PQ DOCUMENTS

Revoren Group Brochure

Revoren Executed / Current Projects Project Approvals

DUBAI SOUTH / AL BURJ Engineering Consultants / LOOTAH ENGINEERING AND CONSTRUCTION	DESIGN & BUILD OF THE NOLUS	SHOP DRAWING SUBMITTAL	
		Reference No.	BP159-LEC-SHD-CIV-000020
	RFP 159/BP/21 in Bussines Park of Dubai South	Rev. No	1
		Date Submitted	28-Dec-21
Originator of Submittal	LOOTAH ENGINEERING AND CONSTRUCTION LLC	No. of hardcopies	Soft copy

DATE
DRAWN BY	MUSTHAFA	05-12-2021
CHECKED BY	SARA	
APPROVED BY	SARA	
SCALE	A1 / AS SHOWN	
DRAWING NUMBER	BP159-LEC-SHD-CIV-000054	REV 0

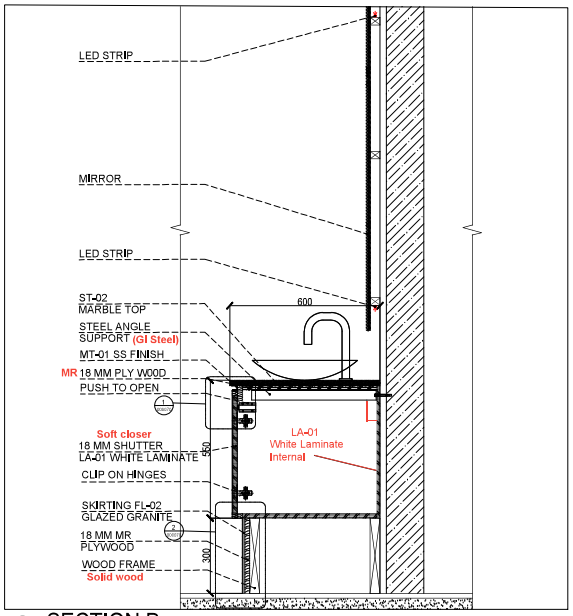
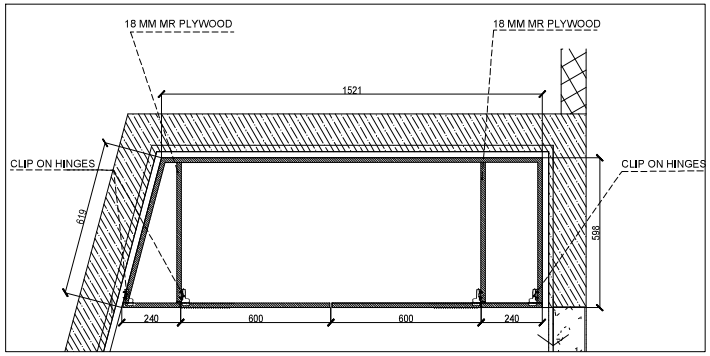
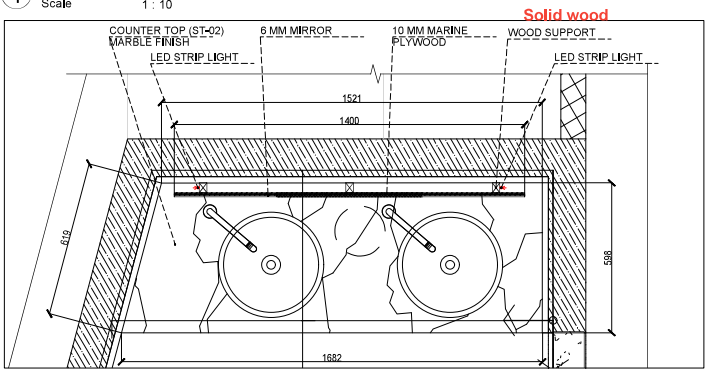
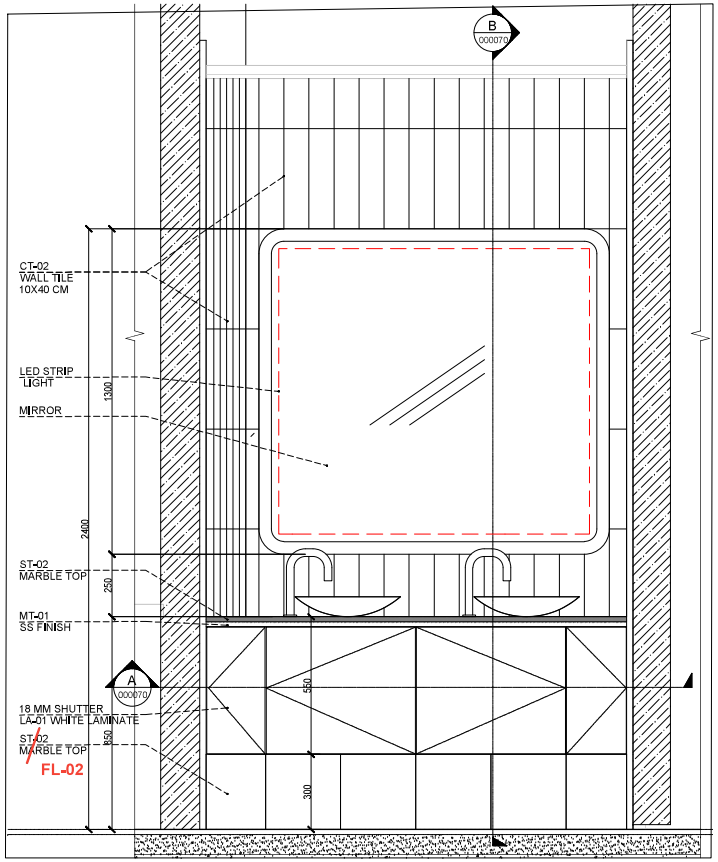
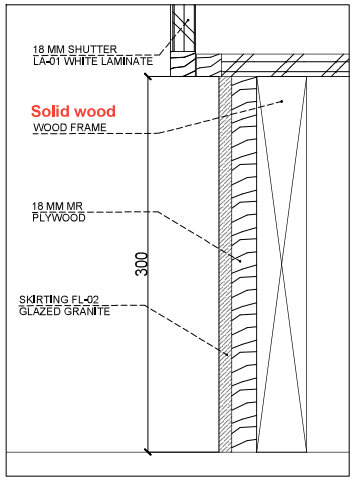
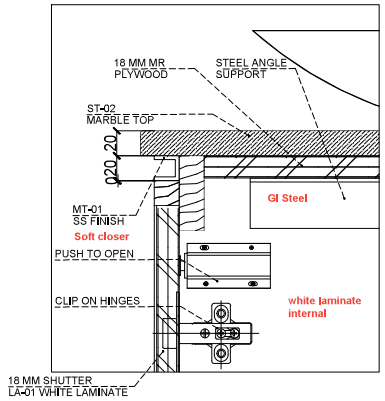
- See comments on the attached details drawing.
- White Laminate LA-01 to be considered for internal cabinet.
- Material submittal for St-02, LA-01 to be submited.
- All wood frames to solid wood, material submittal to be submited.
- Only GI steel support to be incorporated into work
- Any approval will not relieve Contractor from his liability and subject to no cost and time impact
